SHADOW CREEK SUBDIVISION

APPLICATION NUMBER 3 DATE June 16, 2016

APPLICANT Shadow Creek Subdivision

REQUEST Subdivision

DETAIL SITE PLAN

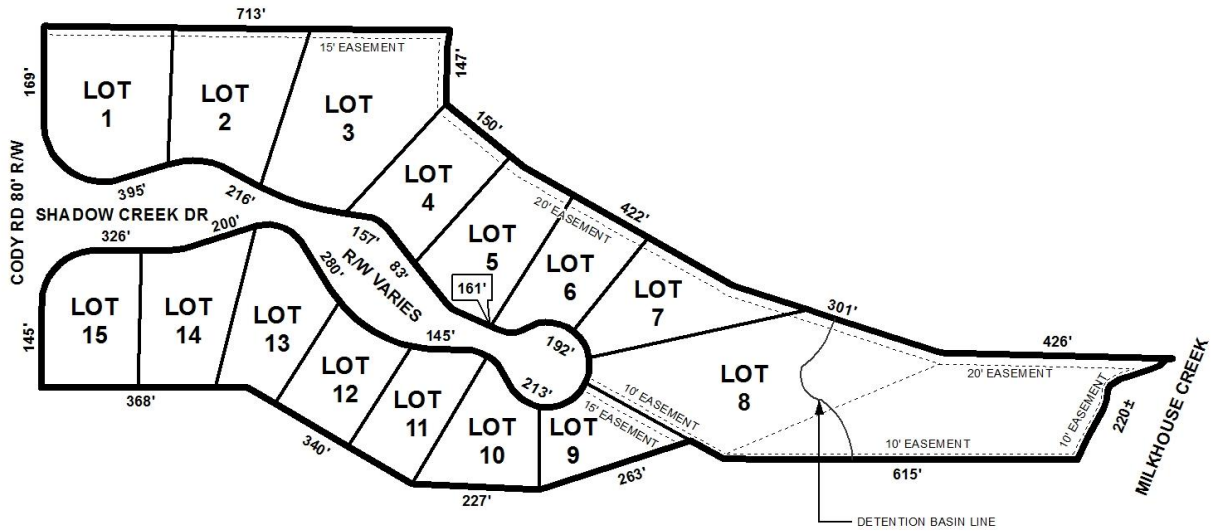
The site has frontage on Sollie Road, a major street with a sufficient 50' distance from the street centerline illustrated on the plat. The right-of-way width of Sollie Road is labelled as 80', but it appears to have been 100' since 2001. The preliminary plat incorrectly labels Sollie Road as Cody Road. If approved, the Final Plat should correctly identify Sollie Road and its 100' right-of-way. Shadow Creek Drive is a minor street with curb and gutter, and has a variable right-of-way, but no dedication is required as the road meets minimum required distance for both one-way and two-way traffic.

As a means of access management, and per previous Subdivision approval, a note should be required on the Final Plat stating that Lots 1 and 15 are denied access to Sollie Road. The note should also mention that all lots are limited to one curb cut to Shadow Creek Drive, with any changes in their sizes, locations, or designs to be approved by Traffic Engineering and conform to AASHTO standards.

The applicant mentions a desired 35' minimum building setback requirement for each of the proposed lots; however, the required minimum building setback line is 25' per Section V.D.9. of the Subdivision Regulations. If the applicant chooses to require a 35' minimum building setback line for each of the proposed lots, then this information should be illustrated on the Final Plat, if approved.

It should be noted that Lot 8 exceeds the maximum width-to-depth ratio established by Section V.D.3. of the Subdivision Regulations; however, previous approval of the lot would suggest that a waiver of this section may be appropriate. Nevertheless, each lot meets the minimum size requirements of the Subdivision Regulations; however, none are appropriately labeled on the preliminary plat. If approved, lot size information should be illustrated on the Final Plat in square feet and acres, or a table should be furnished on the Final Plat providing the same information.

A 15' drainage easement is illustrated along the North property lines of Lots 1-3; a 20' drainage easement is illustrated along the North Property lines of Lots 4-8; and a sanitary sewer easement is illustrated between Lots 8 and 9. A note should be required on the Final Plat stating that no structures shall be erected in any easements, if approved.

A portion of the site is illustrated as wetlands and, as such, may be considered environmentally sensitive; thus, approvals from the appropriate local, state and federal agencies may be required prior to the issuance of any development permits.

Furthermore, it appears as if the preliminary plat was not prepared by a licensed professional land surveyor or engineer. It should be noted that the Final Plat should be prepared by either a licensed professional land surveyor or engineer.

- 1) final Plat to be completed by either a licensed professional land surveyor or engineer;
- 2) placement of a note on the Final Plat stating that Lots 1 and 15 are denied access to Sollie Road, and that all lots are limited to one curb cut to Shadow Creek Drive, with any changes in their sizes, locations, or designs to be approved by Traffic Engineering and conform to AASHTO standards;
- 3) retention of all illustrated common areas;
- 4) placement of a note on the Final Plat stating that maintenance of all common areas shall be the responsibility of the property owners;

- 5) illustration of at least a minimum 25' building setback line for each lot on the Final Plat;
- 6) illustration of the lot sizes, for each lot, in square feet and acres on the Final Plat, or furnishing of a table providing the same information on the Final Plat;

- 7) placement of a note on the Final Plat stating that no structures shall be erected in any easements;
- 8) revision of the Final Plat to correctly label Sollie Road and its right-of-way width;
